## TECHNICAL NOTE TN-1070-SR

### First Commercial Release of TM8200 MPT1327 Firmware v2.05

5 September 2005

This Technical Note applies to the TM8200 Mobile radio platform.

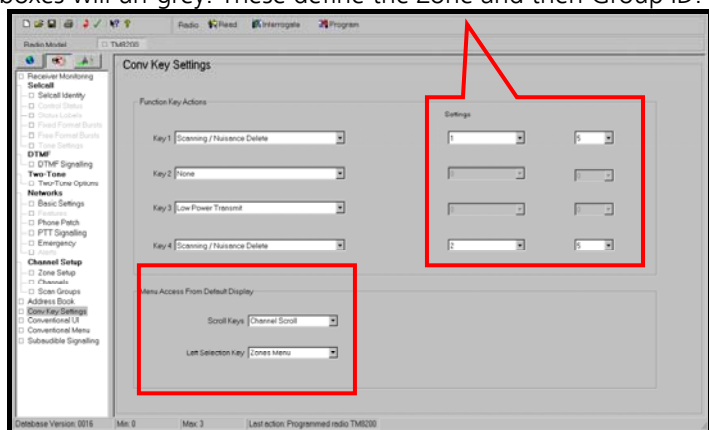
Updates in v2.05 firmware for TM8200 Conventional operation.

- If Enable User Editing of scan group in Scan Groups > Common Options is enabled, the Add/delete channel(s) from a Scan group, in the menu, is permanent. This is not to be confused with Nuisance Delete, as a Function key option, which is only temporary for the duration of that active Scan group.
- TM8200 Users who have a GPS receiver connected can now display the received NMEA string's information to screen. The display options are:
  - Latitude
  - Longitude
  - Course (in degrees)
  - Speed (in kph)
  - UTC Time
